Applies To: See VEHICLES AFFECTED

October 29, 2004

### Safety Recall: Automatic Transmission Second Gear Inspection (Supersedes 04-021, dated July 9, 2004)

### ***A/T BEFORE INSTALLATION OF A/T OIL JET KIT***

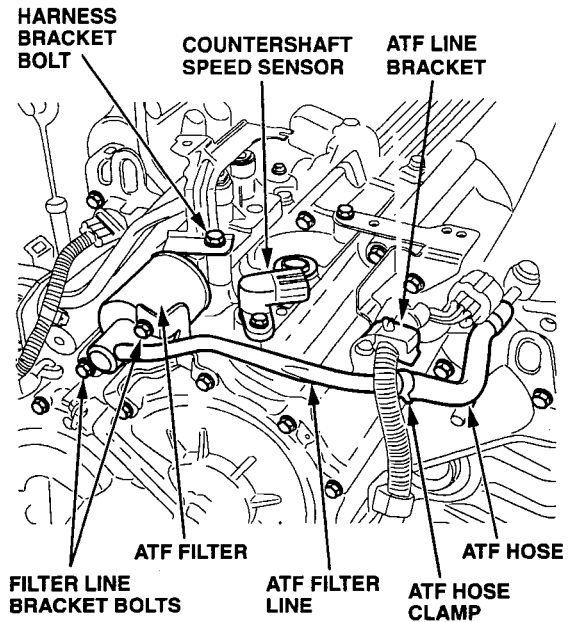
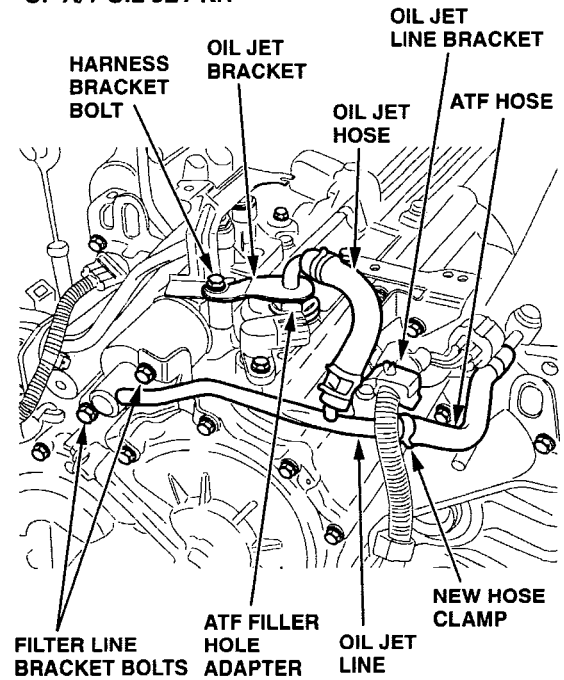
5. Detach the wire harness from the ATF line bracket.
6. Remove the filter line bracket bolts, then remove and discard the ATF filter line assembly.

- Assemble the A/T Oil Jet Kit out of the vehicle, but do not attach the oil jet to the oil jet hose yet.

- Each hose clamp has a retainer to hold it in its spread position. To install a hose clamp, slide it into position (7 mm from the end of the hose), then pull off the retainer with pliers.
- Use clean ATF to assemble all metal-to-rubber lines and hoses. Do not use grease or any other lubricants.
- Make sure you insert the oil jet into the base of the "T" on the oil jet line.

- Install the oil jet line on the ATF hose with a new hose clamp.

- Make sure there are no kinks in the oil jet hose when you install it onto the transmission.

**A/T AFTER INSTALLATION OF A/T OIL JET KIT**

- Install the other end of the oil jet line onto the ATF filter, and tighten the filter line bracket bolts to 12 N·m (8.7 lb-ft).
- Remove the harness bracket bolt.
- If not already done, remove and discard the ATF filler bolt.
- Install the ATF filler plug adapter with a new sealing washer, and torque the adapter to 44 N·m (33 lb-ft).
- Insert the oil jet into the ATF filler plug adapter, and make sure the oil jet is flush. Position the oil jet bracket over the harness bracket bolt hole. Reinstall the harness bracket bolt, and torque it to 27 N·m (20 lb-ft).
